**ADDENDUM NO. 2 – RFB-460
HVAC Upgrades – Falcon Center, Feaster Center, and Hunt Haught Hall
Fairmont State University
Fairmont, WV**

DOCUMENTS AMENDED

S100
DRAWING NUMBER

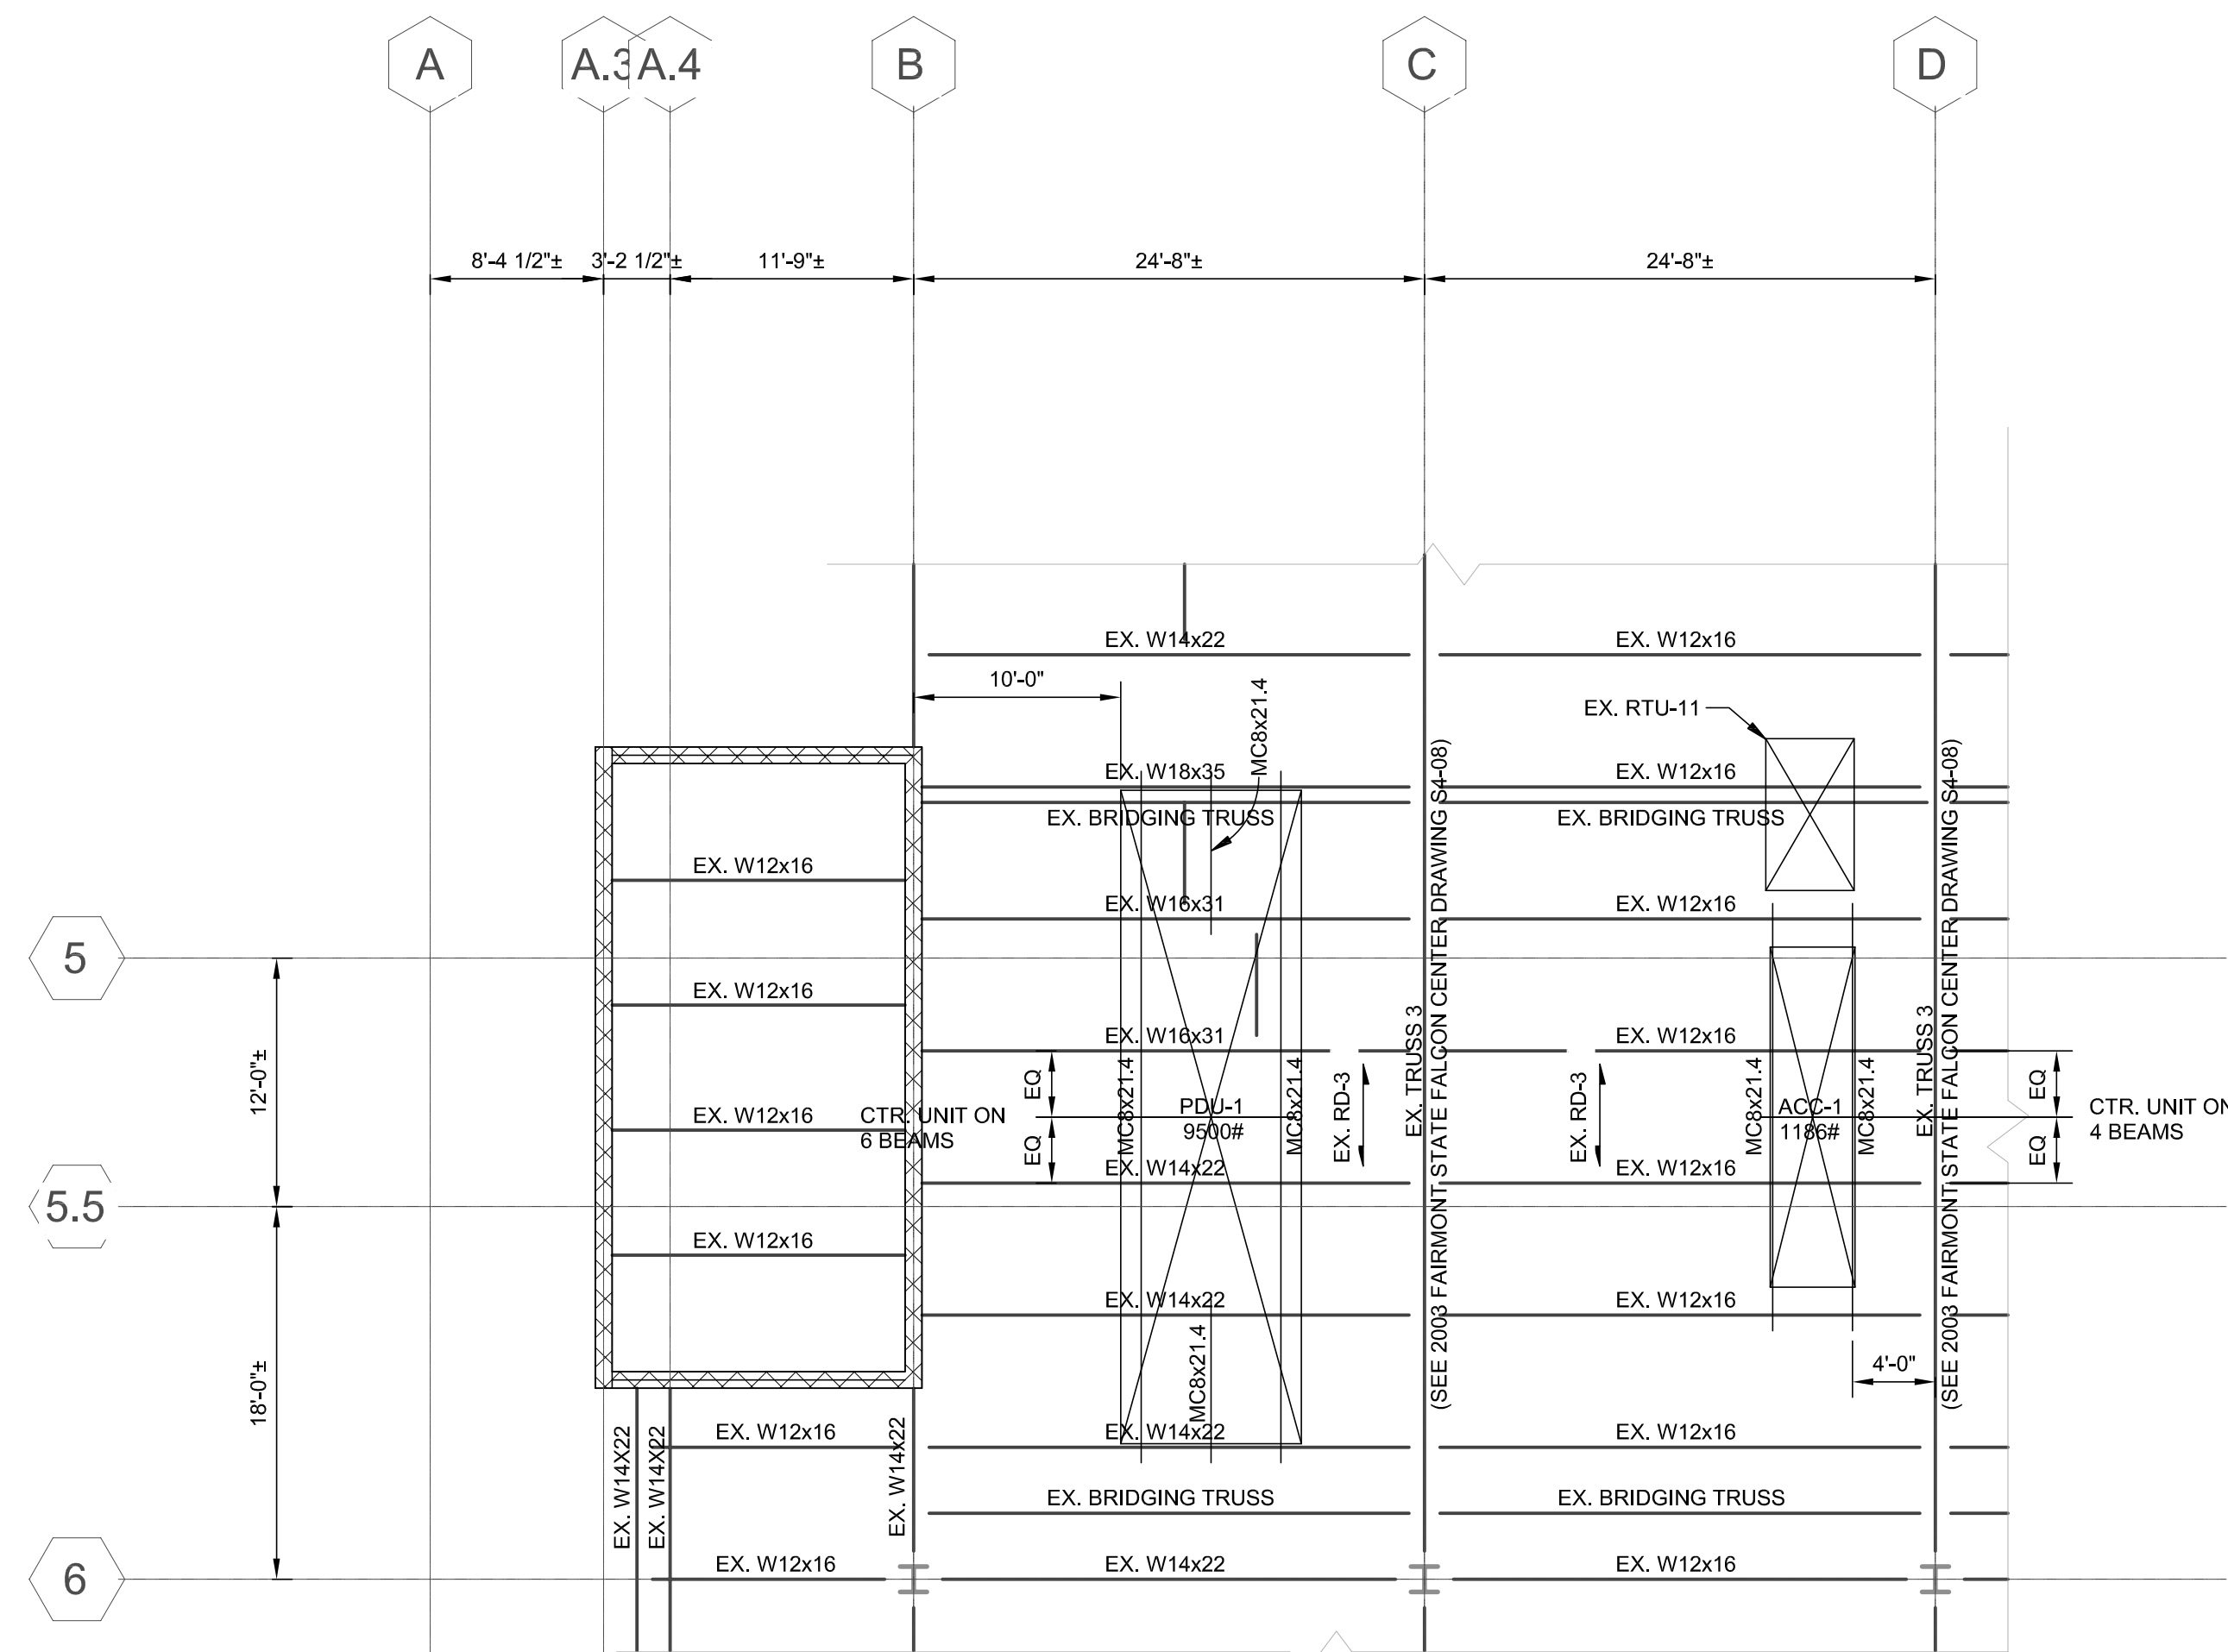
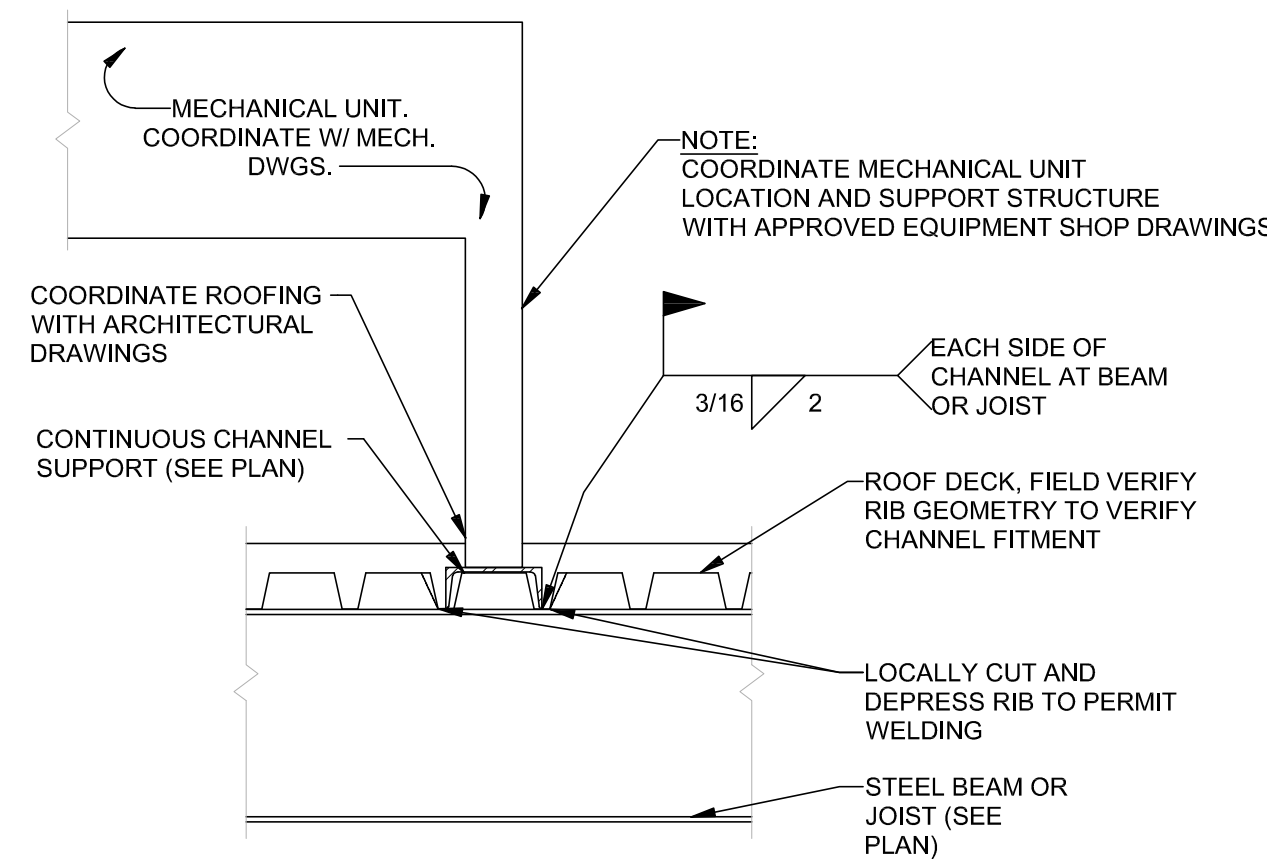
2. Drawing S100
 - a. Add S100, which is included in this addendum, to the Construction Documents.
